## 2.5.4 Stability of Subsurface Materials and Foundations

Figure 2.5.4-4 - ESP Site-Specific Base Shear Wave Velocity Profile

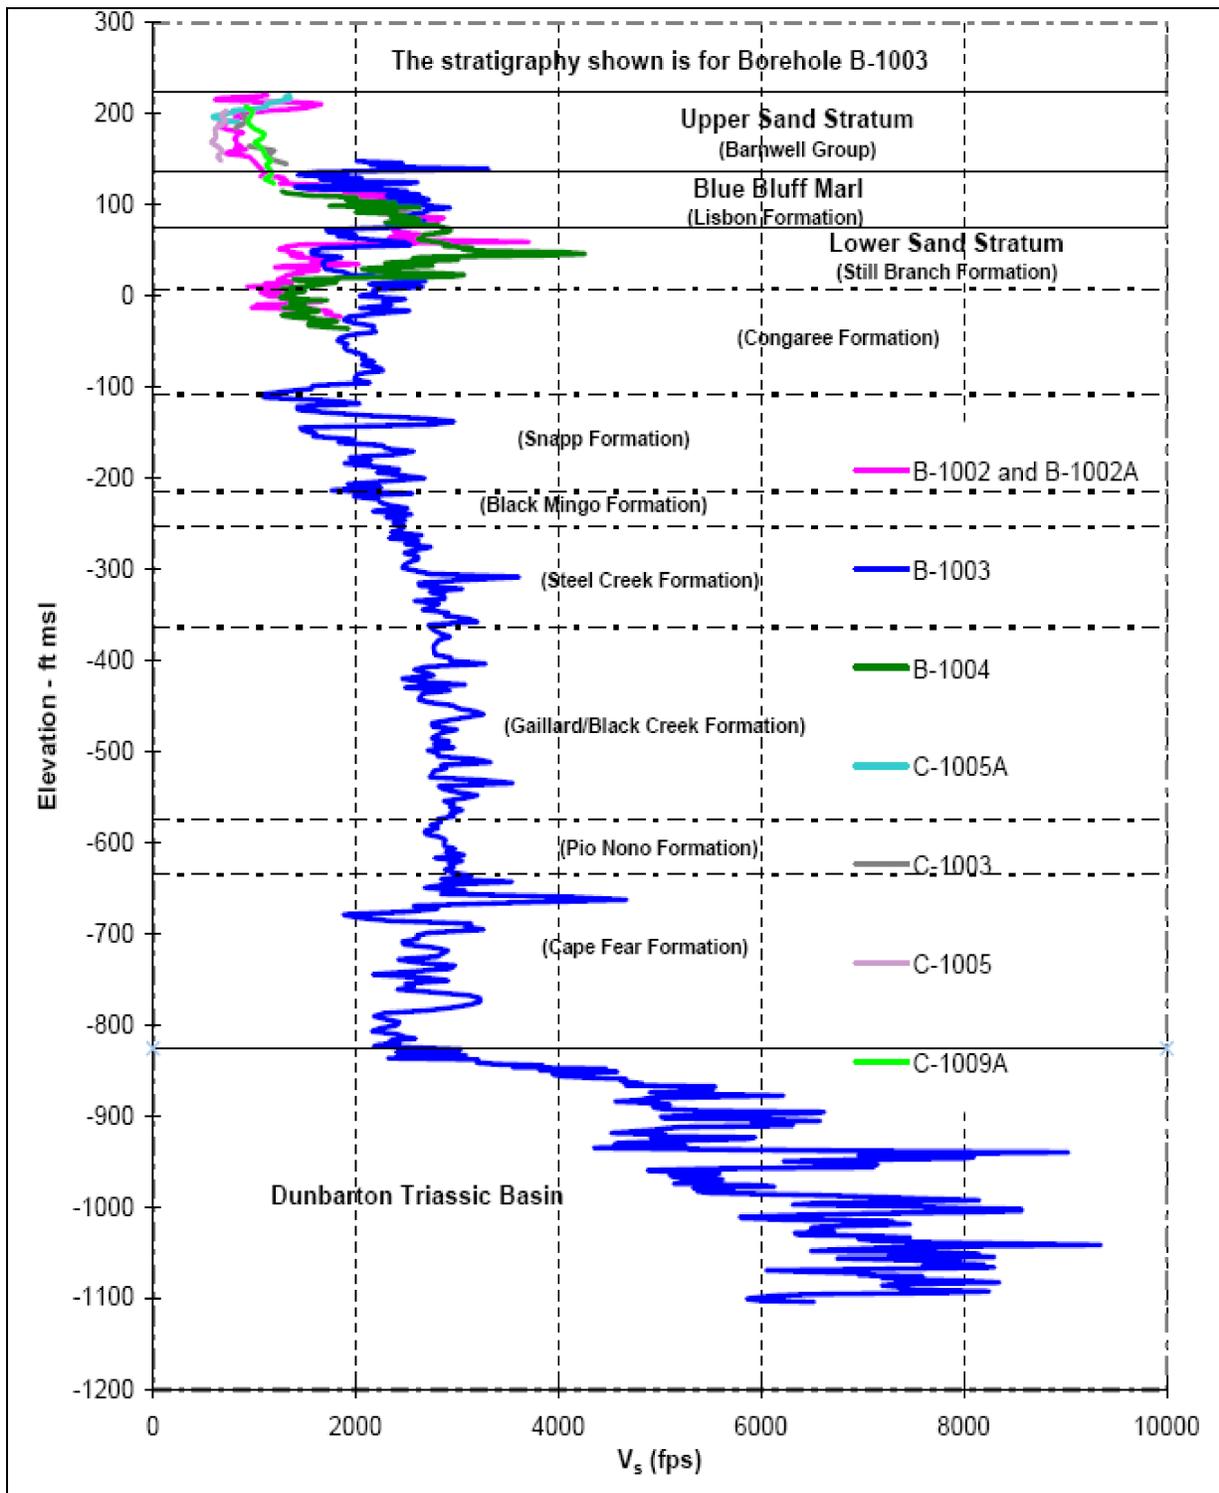
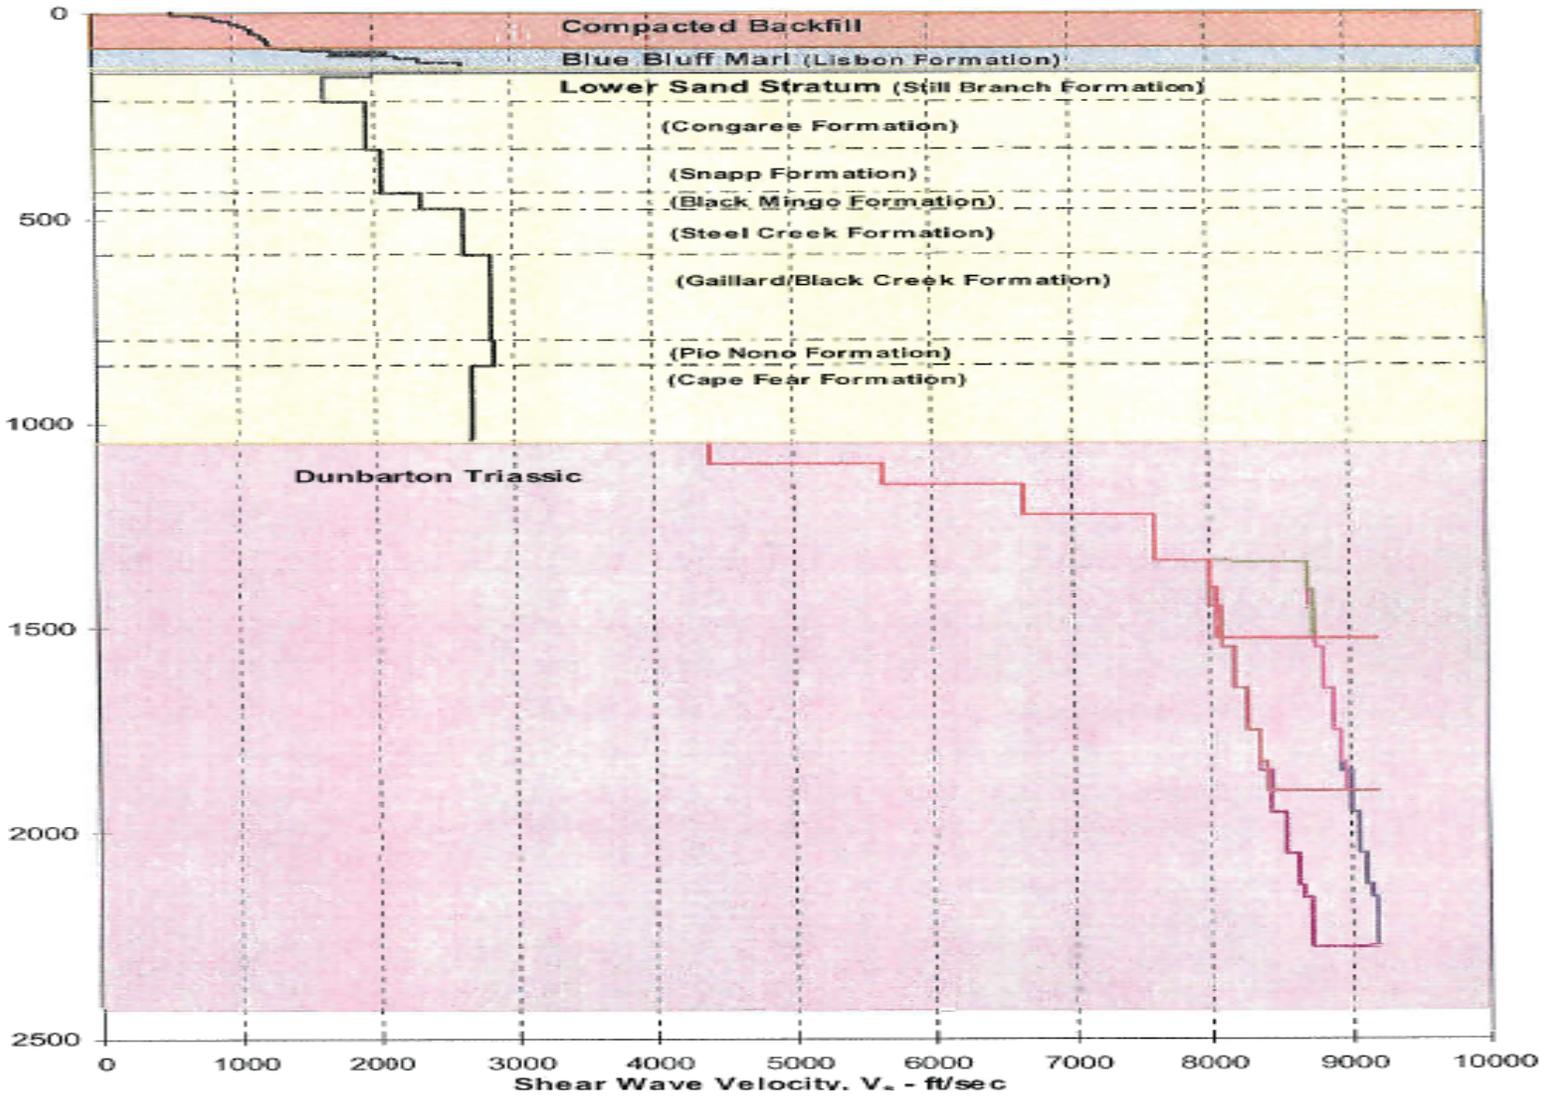
In RAI 2.5.4-3, the staff asked the applicant to explain how it developed the base case shear wave velocity profile based on only 12 borings, since most of them did not go deeper than 91.4 meters (300 ft). In its response to RAI 2.5.4-3, the applicant stated that it developed the base case shear wave velocity profile associated with the Lisbon Formation (Blue Bluff Marl), Still Branch Formation, and the upper portion of the Congaree Formation from the results of the three suspension P-S velocity logging tests performed at the ESP site. One of the suspension P-S velocity logging tests extended into bedrock below the Lower Sand Stratum, and the applicant used those results to derive the base case shear wave velocity profile below the top of the Congaree Formation. The applicant explained that its randomization model, which captures the uncertainty in the base case shear wave velocity profile for the in situ soils, used logarithmic standard deviation of shear wave velocity as a function of depth, which is set to values obtained from soil randomization performed at SRS. After reviewing the applicant's response, the staff, however, finds that shear wave velocities vary significantly among the three profiles (ESP, VEGP, Units 1 and 2 and SRS, most of them terminate at a depth of about 85.34 to 60.96 meters (280 to 300 ft)), shear wave velocities measured from down-hole seismic tests are lower than the suspension P-S velocity measurements. Furthermore, the shear wave velocities from previous investigations were relatively lower than those obtained from the ESP investigations. Therefore, the staff concludes that the applicant did not provide sufficient shear wave velocity measurements to define the site-specific shear wave velocity profile. This is **Open Item 2.5-18**.

Based on its review of SSAR Section 2.5.4.4 and the applicant's response to RAI 2.5.4-3, described above, the staff concludes that the applicant used various methods to determine compressional and shear wave velocities, including some of the latest technologies recommended in RG 1.132. However, the applicant did not provide sufficient shear wave velocity measurements to define the site-specific shear wave velocity profile and address the velocity difference from different methods.

**Figure 2.5.4-5 - Shear Modulus Reduction Curve For SHAKE2000 Analysis—EPRI Curve  
(Reproduced from SSAR Figure 2.5.4-9)**

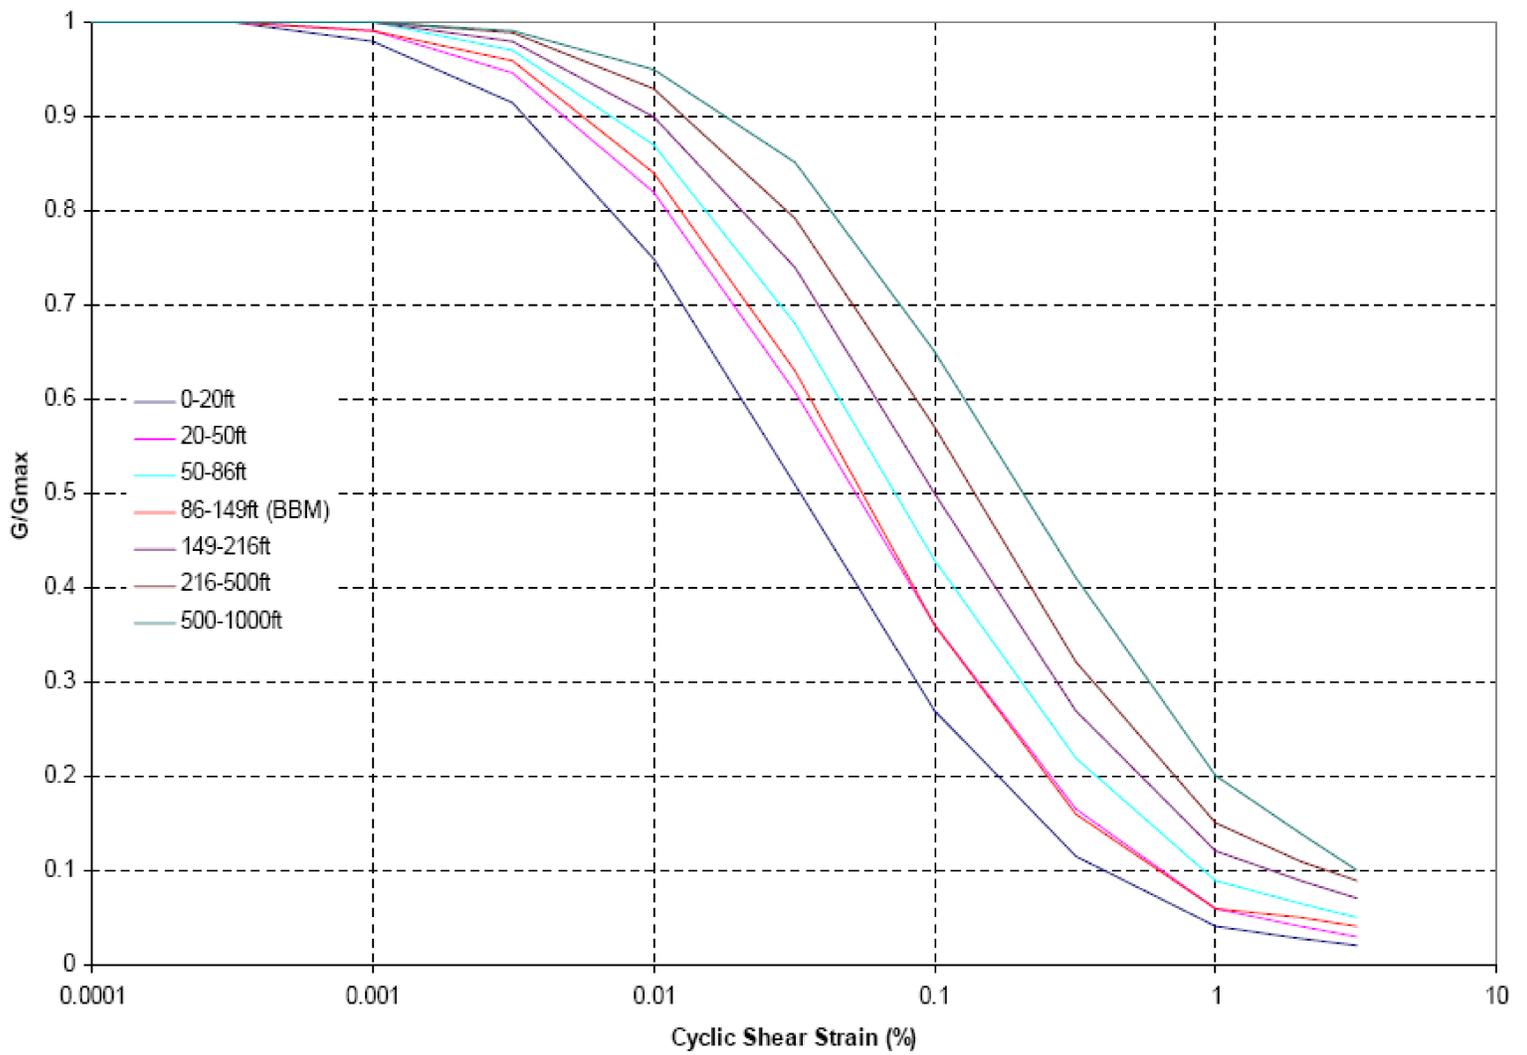
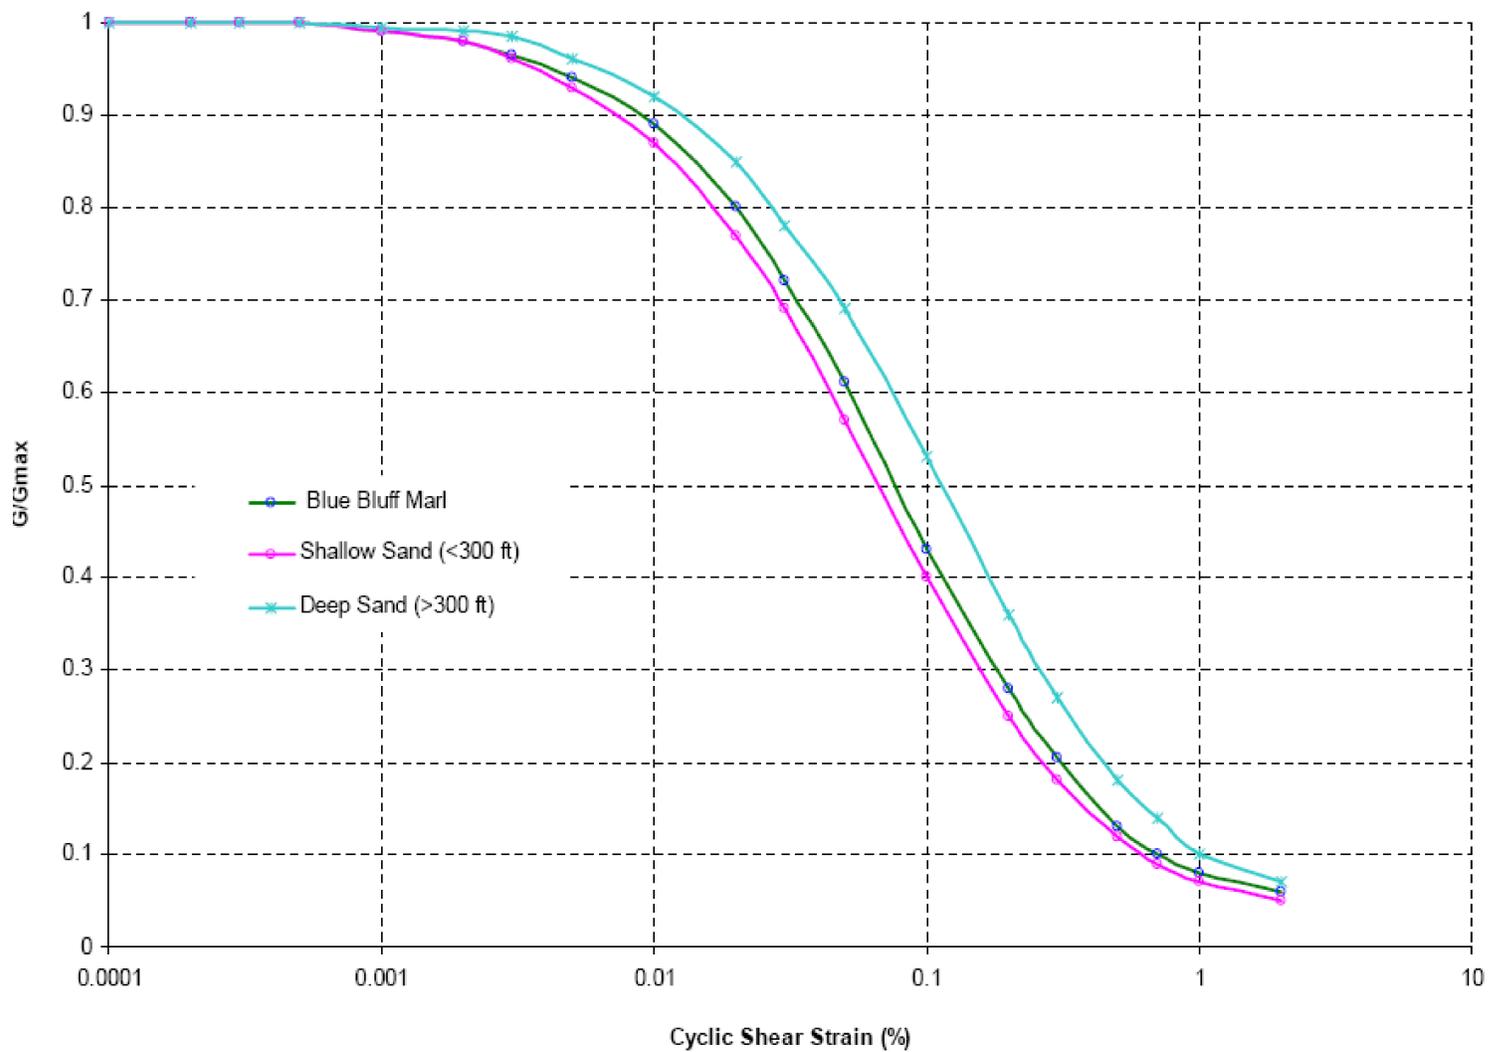
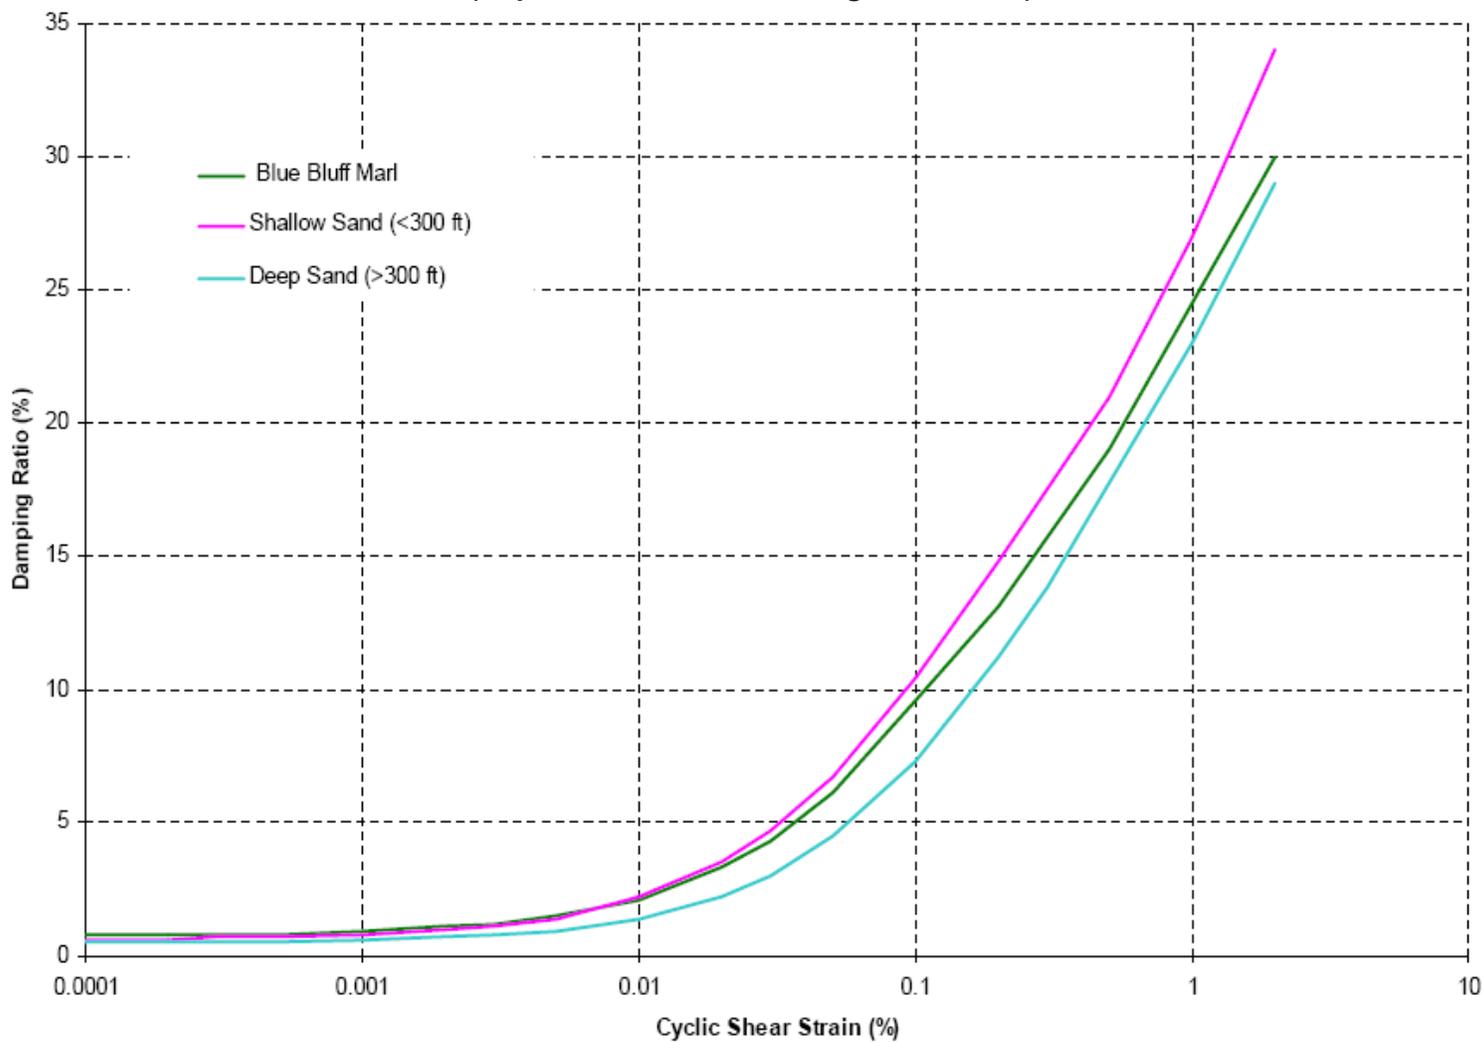
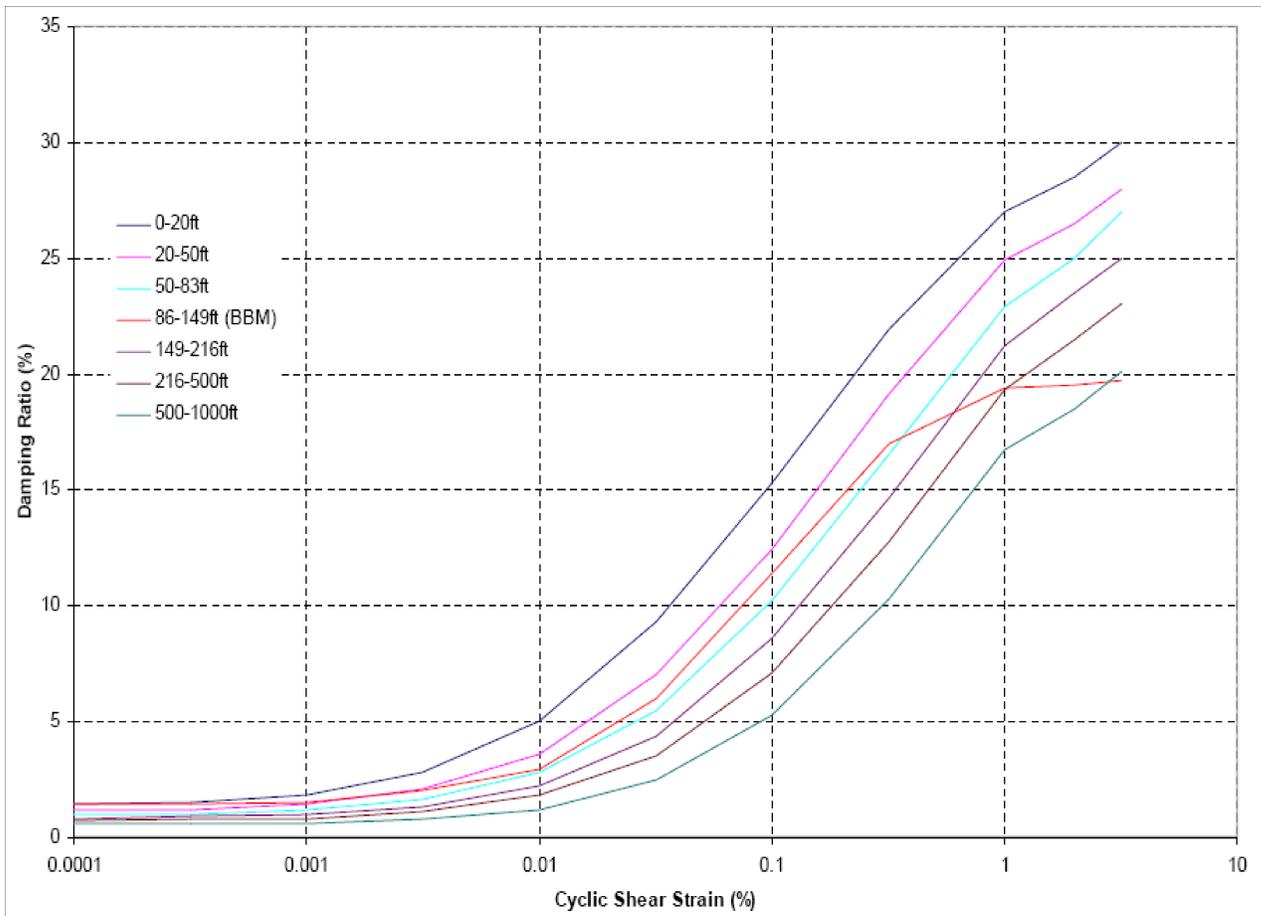
The applicant derived ESP soil shear modulus degradation and damping curves from the curves developed by EPRI (1993). In RAI 2.5.4-5, the staff asked the applicant to justify its application of the EPRI curves to fine-grained soils. In its response, the applicant stated that EPRI (1993) developed degradation curves for soils from gravels to high plasticity clays, and thus it was appropriate to apply the curves to fine-grained soils. EPRI (1993) presented fine-grained soils in Figures 7.A-16 (shear modulus reduction curves) and 7.A-17 (damping ratio curves) in terms of soil plasticity and required the use of the PI. The applicant referred the staff to its response to RAI 2.5.4-17 for more details on how it derived the degradation curves from the EPRI (1993) curves. The applicant further indicated that it would verify the soil degradation relationships for fine-grained soil (and coarse-grained soils) used in the SSAR by laboratory testing during COL subsurface investigation.

After reviewing the applicant's response and its references, the staff finds that Section 7A.6 of the EPRI (1993) report recommends the modulus degradation and hysteretic damping strain-dependent curves for generic CEUS sites. According to the report, these curves are intended for gravelly sands to low plasticity silty or sandy clays and should not be applied to either very gravelly or very clayey deposits. The curves presented in the report for silts and clays of high plasticity are significantly different from those for sandy soils. In its response to RAI 2.5.4-10, however, the applicant indicated that the Blue Bluff Marl "is described as hard, slightly sandy, cemented calcareous clay, and with less than 50% fine material," which is different from the type of materials for which the curves are intended. Therefore, the applicant did not adequately explain why it is appropriate to apply those relationships to the silts and clay soils at the ESP

site. The report further states that, while the generic curves are appropriate for preliminary site studies, one should use site-specific data for final evaluations. In conclusion, the staff concurs with the applicant that it needs to verify the soil modulus degradation and damping curves. However, this verification should not wait until the COL stage. Without site-specific soil modulus degradation and damping curves, the determination of site-specific GMRS (SSE) is inadequate. To provide site-specific soil degradation and damping ratio curves for the site-specific soil amplification calculation discussed in SER Section 2.5.2 is **Open Item 2.5-19**.

Because the applicant stated in the SSAR that it used values of shear modulus and damping ratio provided by Silva (2006) to extend the EPRI curves beyond the 1- to 3.3 percent strain level, in RAI 2.5.4-13, the staff asked the applicant to justify how it extended the values beyond the 1 percent strain level and to provide a complete description and supporting data. In its response, the applicant stated that, even though it extended the EPRI curves beyond the 1 percent strain level, the maximum strains calculated during the site amplification analyses remained below 1 percent. But, the applicant then stated that it would revise SSAR Sections 2.5.2.5.1.5, 2.5.4.7.2.1, and 2.5.4.7.2.2, along with associated tables and figures, to show the degradation curves only at a 1- percent or less cyclic shear strain. Due to the applicant's commitment to revise the curves back to a 1 percent strain level without extrapolation, the staff concludes that this RAI is not resolved until the revised SSAR sections are submitted for review. This is **Open Item 2.5-20**.

6. Other RAI responses indicated that the applicant used both SRS and EPRI (1993) models in the site response analyses and weighted them equally. Considering that site-specific data are almost always desired over generic models, the applicant needs to evaluate the strain level difference in the surface UHRS at different exceedance levels that result from application of these different models and to justify if the equal-weighting approach is appropriate.
